# Bardstown Road/Baxter Avenue Corridor Review Overlay (BROD) District

20-OVERLAY-0002

Hensley Hotel, 1125 & 1131 Bardstown Rd

# Request

## PATIO & BUILDING FACADE

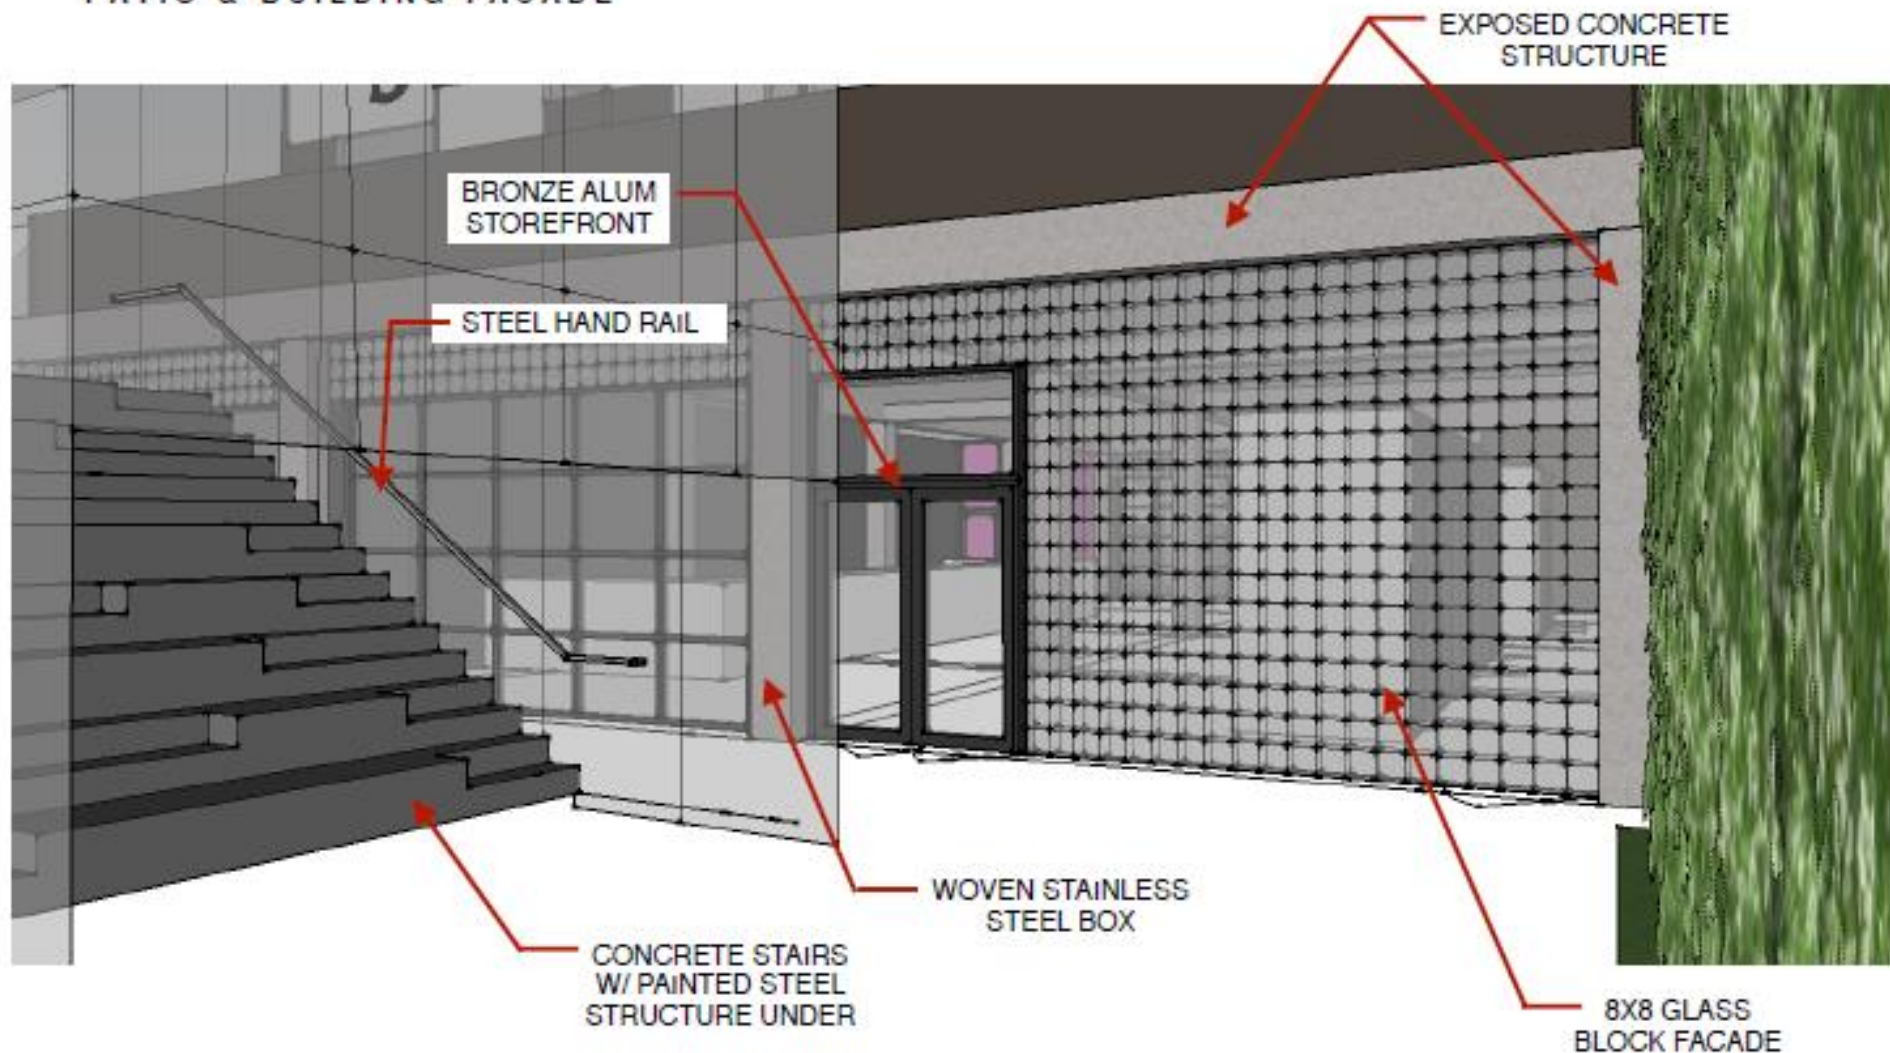
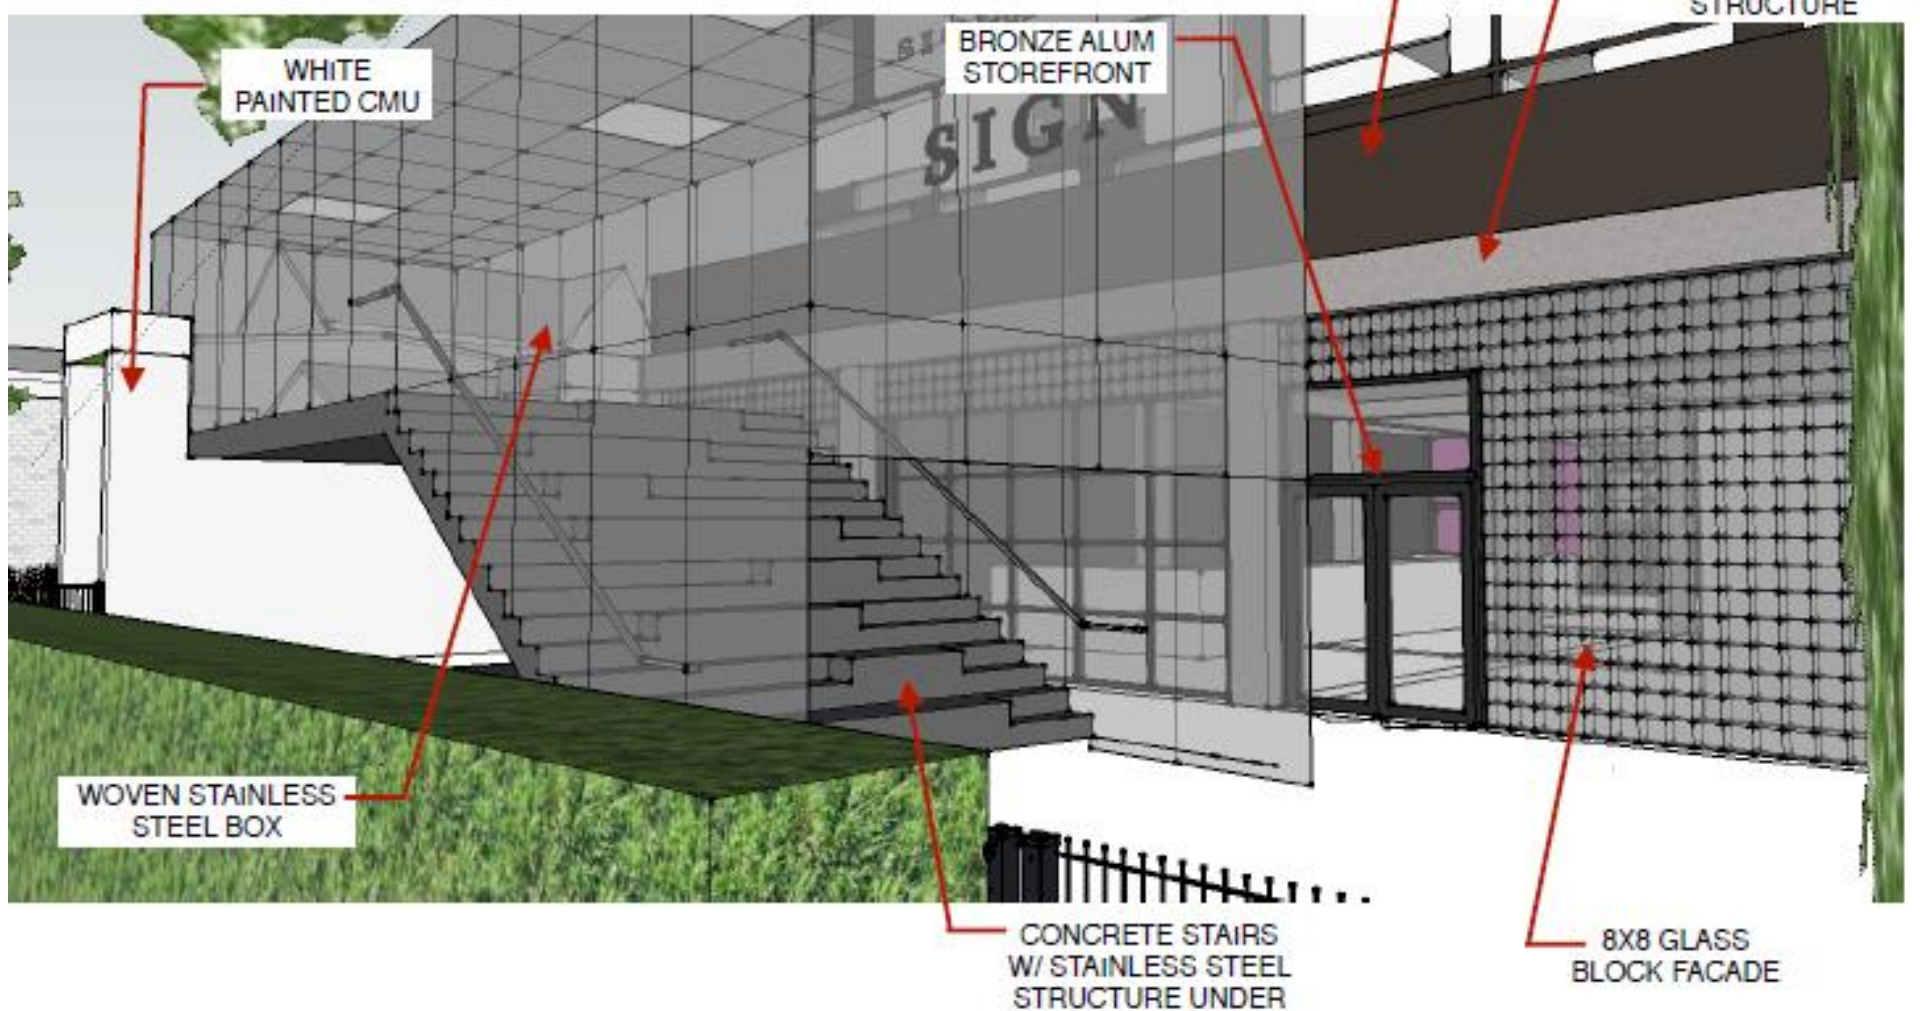
5. Final design and detailing of the front area of the 1 story bar building shall be submitted for staff level review and approval indicating building materials, plantings, lighting, stair and screen detail.
